INTERNAL MEMORANDUM

To:	Gareth Davies
From:	Matt Davies (Ecologist)
Ext:	5278
Memo number:	3 Final_2
Date of previous memo (for P/23/0065)	15/07/2024
Date:	20/11/2024

SUBJECT: P/23/0065 | Outline application for erection of a mixed leisure development comprising Indoor Snow Centre (up to 39,200 sq m), Water park (up to 7,500 sq m), Indoor Activity Centre (up to 9,000 sq m), Outdoor Activity Centre, Hotel Accommodation (up to 418 bedrooms), Woodland Lodge accommodation (up to 30 units), car parking (up to 830 spaces) and associated earthworks, access, drainage, servicing and utilities connections/infrastructure | Land To The South West Of The A470/A4102 Roundabout At Rhydycar West Merthyr Tydfil

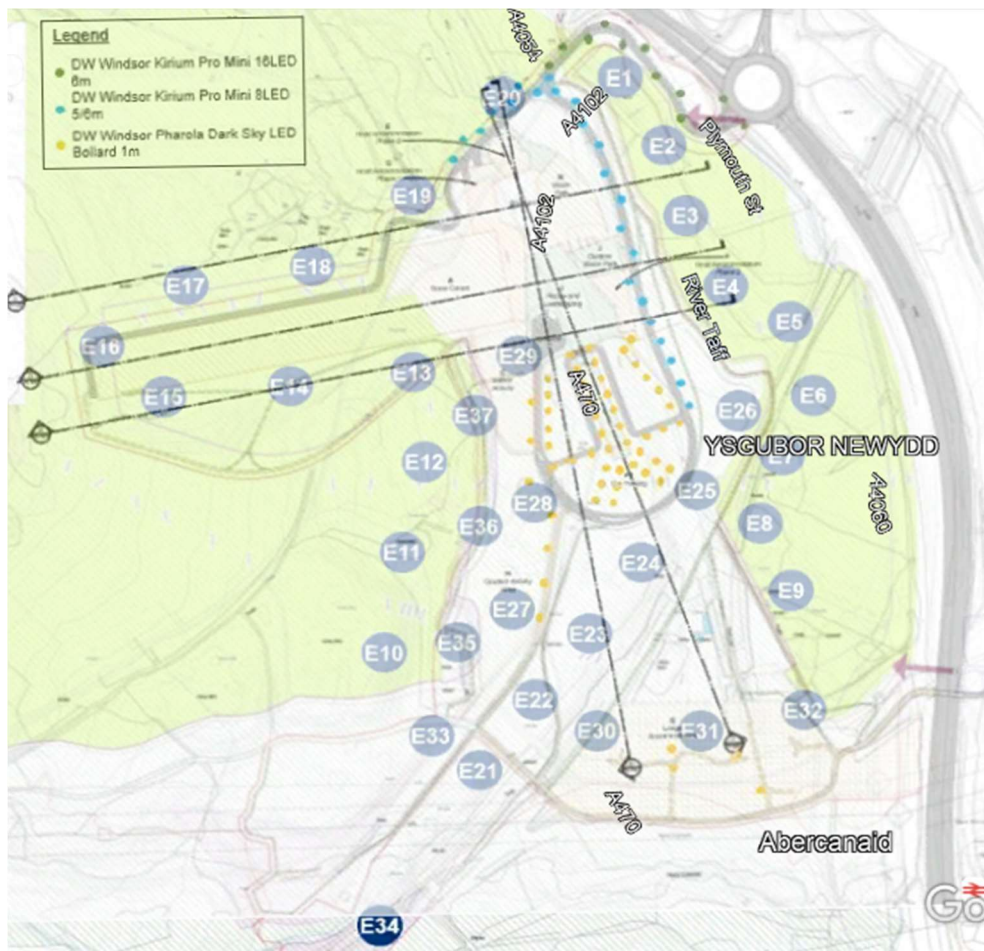
Also, E20 seems to be very close to a line of lighting columns, yet the illuminance level is very low (0.01lux). Is this correct?

In addition, Table 4.2 shows the baseline lux levels and, for example, location 1 (L1) has an illuminance level of 0.05lux (facing east). L1 is in the same position as E20, but the 'baseline' illuminance level (pre-lighting) is higher than the predicted model illuminance (post-lighting)?

Can this be explained please?

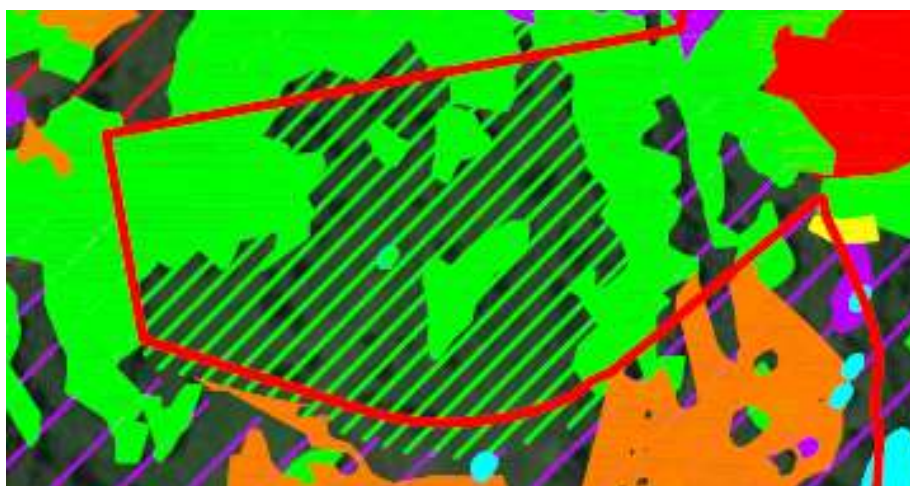
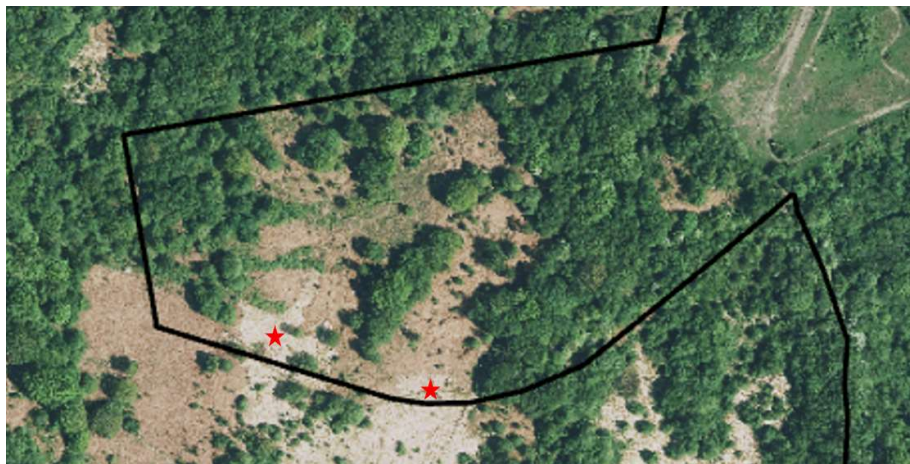
1. The habitats within the section of SSSI to be impacted by the proposed development (as mapped by Bioscan) include ‘Woodland and Scrub’, ‘Bracken Ffridd’ (these two habitats combined dominate), with smaller areas of ‘Purple moorgrass rush pastures’, ‘Lowland heathland’ and plus a habitat type not included within the key (shown on the plan as purple diagonal lines).

Furthermore, aerial imagery of the area in question from 2023 shows other clear areas of marshy grassland (Molinia) on the southern boundary (near the red stars) shown on the habitat map as within the Bracken Ffridd – see plans below.
